Template for comments and secretariat observations

Document: **ACDC 02-04e GWG
Comments on ACDC 02-03e**

Project: ACDC

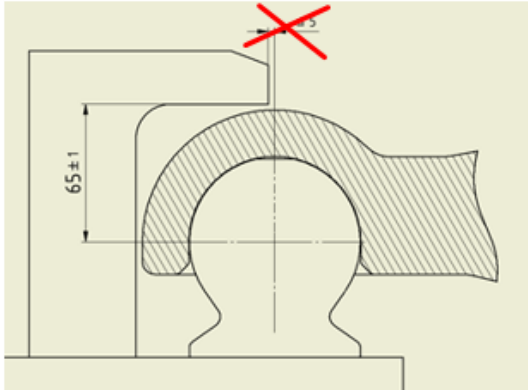
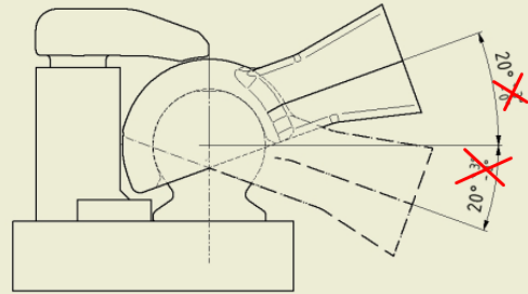
MB/ NC ¹	Line number	Clause/ Subclause	Paragraph/ Figure/ Table/	Type of comment ²	Comments	Proposed change	Observations of the secretariat
G WG		2.8	Second paragraph	te	"Drivers direct field of vision" could be understood as view of front window Indication could also be located on different places but still in the drivers field of view	When installed in the vehicle cab, the remote indication devices shall be mounted within the driver's direct field of vision, and be clearly identified.	Delete 2 nd and 3 rd paragraph and keep here only the definition (as in R 55). Add the requirements of 2 nd and 3 rd paragraph into Annex 5 or 7 (Follow approach of R 55). <i>Remark: 2nd and 3rd paragraph inserted at the end of paragraph 4.5.</i>
G WG		3.2.2	Item	ge	Numbers of drawings sets should be defined by Type Approval Authority	Three sets of d Drawings which are sufficiently detailed to define the device or component and which specify how it is to be fitted to the vehicle;	Accepted.

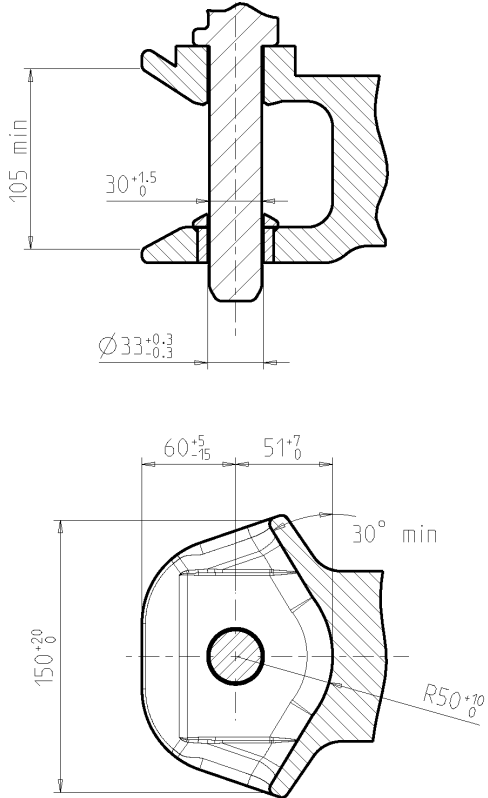
MB/ NC ¹	Line number	Clause/ Subclause	Paragraph/ Figure/ Table/	Type of comment ²	Comments	Proposed change	Observations of the secretariat
G WG		Annex 5	3.1.5	te	Requirement of 70 degrees articulation in the vertical axis is committed in all common designs and regulations. Reduction could result in significant problems by the interchangeability of parts	a) Vertical axis: ± 60 70 [°]	Accepted. Insert before the angles min.
G WG		Annex 5	Figure 5	te	The new drawing shows the relevant and necessary dimensions of the structural components in regard of their strength and their interchangeability. Further dimensions and requirements are fixed in other paragraphs and documents and would only be repeated here.	<p>preferred version</p>	<p>Accepted for the moment but replace -2 by -7 at value 38 and 30.5 +/- 0.5. Delete "preferred version". New figure according to ISO 6489-2 without superfluous values figure awaited.</p> <p>Keep the approach of two different figures for the cylindrical and the bulged pin.</p> <p>Remark: Drawing will be amended in Rev. 2.</p>

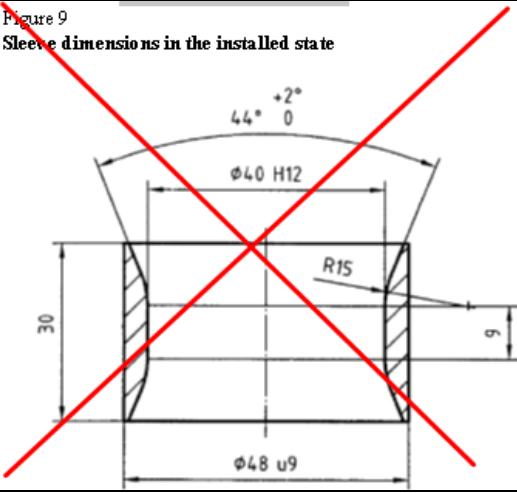
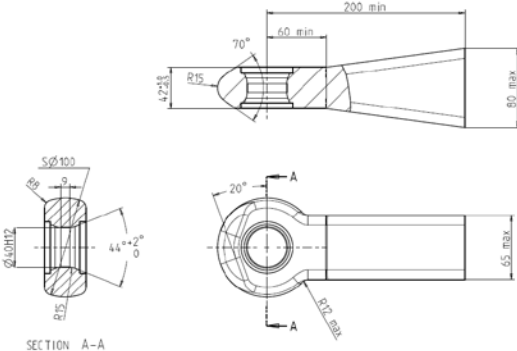
MB/NC ¹	Line number	Clause/Subclause	Paragraph/Figure/Table/	Type of comment ²	Comments	Proposed change	Observations of the secretariat
G WG		Annex 5	Figure 8	te	In the adequate ISO Standard the 40 H12 is a unified dimension for version with and without sleeve. cut section needs to be turned to simplify the view	<p>Figure 8 Principal dimensions of standard drawbar eyes d40-1</p>	Accepted. Remark: Drawing will be amended in Rev. 2.
		Annex 5	4.1.2	te	The detailed information on the sleeves can be found very precisely in the adequate ISO standard. Here it would be just a repetition which is generally described but not complete. Remove complete section	<p>Sleeve 40</p> <p>The sleeve must not be welded into the coupling ring. For Drawbar eyes d40-1 and d40-2, slotted or non-slotted sockets sleeves shall be used. For coupling ring d1-40-3, non-slotted sockets sleeves shall be used. Sleeves shall be connected to the body of the coupling ring so that they cannot become loose during use. The design of the socket sleeve does not have to correspond to the visual representation, it must merely conform to the specified dimensions.</p>	Accepted.

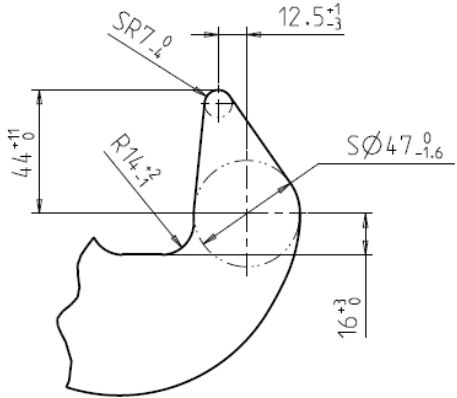
MB/NC ¹	Line number	Clause/Subclause	Paragraph/Figure/Table/	Type of comment ²	Comments	Proposed change	Observations of the secretariat
		Annex 5	Figure 12	te	View is covered with the lower view and can be removed	<p>Figure 12 13 Alternative dimensions of toroidal drawbar eye of class d50</p>	Accepted. Remark: Due to the decision on 4.3.2 above, both figures have to be kept as figure 11 shows the shape of Class d50-1 and figure 12 of Class d50-2.
		Annex 5	6.3	te	Current designs can combine several options of adjustments	Towing brackets can be designed as quick height-adjustable and or horizontal adjustable (qha), pin height-adjustable (pha) bracket or as frame without height adjustment. Towing brackets for quick height adjustable rail plates.	Accepted.

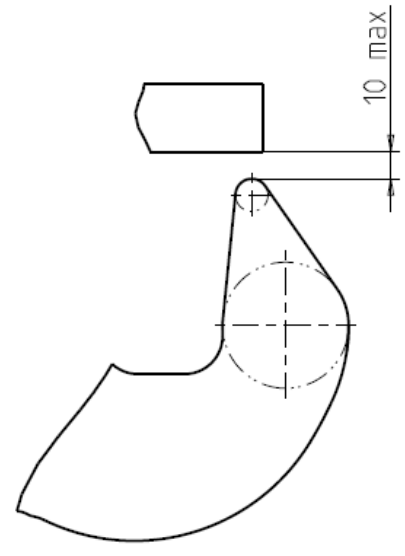
MB/ NC ¹	Line number	Clause/ Subclause	Paragraph/ Figure/ Table/	Type of comment ²	Comments	Proposed change	Observations of the secretariat
		Annex 5	Figure 13	te	The new drawing shows the relevant and necessary dimensions of the structural components in regard of their strength and their interchangeability. Further dimensions and requirements are fixed in other paragraphs and documents and would only be repeated here.	 <p>The drawing shows a cross-section of a structural component. It features a top edge with a chamfered corner labeled SR7₀. A horizontal dimension of 12.5⁺¹₋₃ is shown from the vertical centerline to the start of the chamfer. The total height of the component is 44⁺¹¹₀. A fillet with a radius of R14₋₃ is shown at the bottom left. A circular hole with a diameter of Sϕ47⁰_{-1.6} is located on the right side. The distance from the bottom edge to the center of the hole is 16⁺³₀.</p>	Accepted.

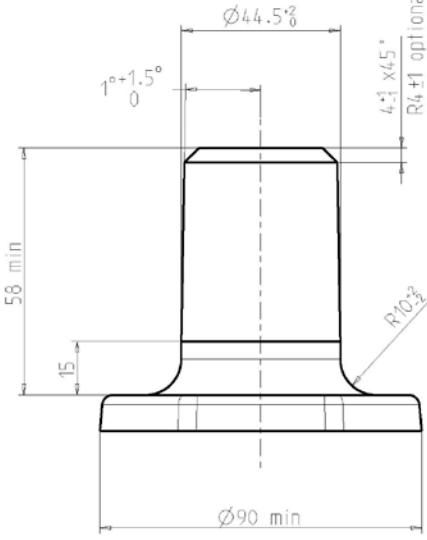
MB/ NC ¹	Line number	Clause/ Subclause	Paragraph/ Figure/ Table/	Type of comment ²	Comments	Proposed change	Observations of the secretariat
		Annex 5	Figure 14	te	The new drawing shows the relevant and necessary dimensions of the structural components in regard of their strength and their interchangeability. Further dimensions and requirements are fixed in other paragraphs and documents and would only be repeated here.	 <p>The drawing shows a structural component with a curved bottom edge and a vertical section on the right. A dimension line indicates a maximum height of 10 units for a specific part of the component. A dashed circle is drawn around the central part of the component, and a horizontal dashed line passes through its center.</p>	Accepted.

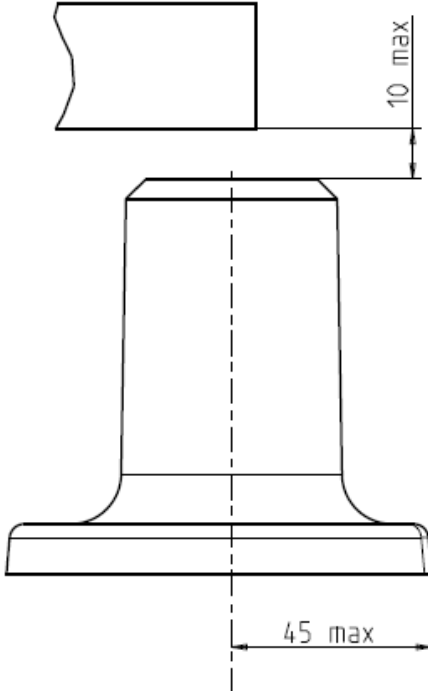
MB/ NC ¹	Line number	Clause/ Subclause	Paragraph/ Figure/ Table/	Type of comment ²	Comments	Proposed change	Observations of the secretariat
		Annex 5	Figure 15	te	The new drawing shows the relevant and necessary dimensions of the structural components in regard of their strength and their interchangeability. Further dimensions and requirements are fixed in other paragraphs and documents and would only be repeated here.		Delete Diameter-Symbol at value 90 min.
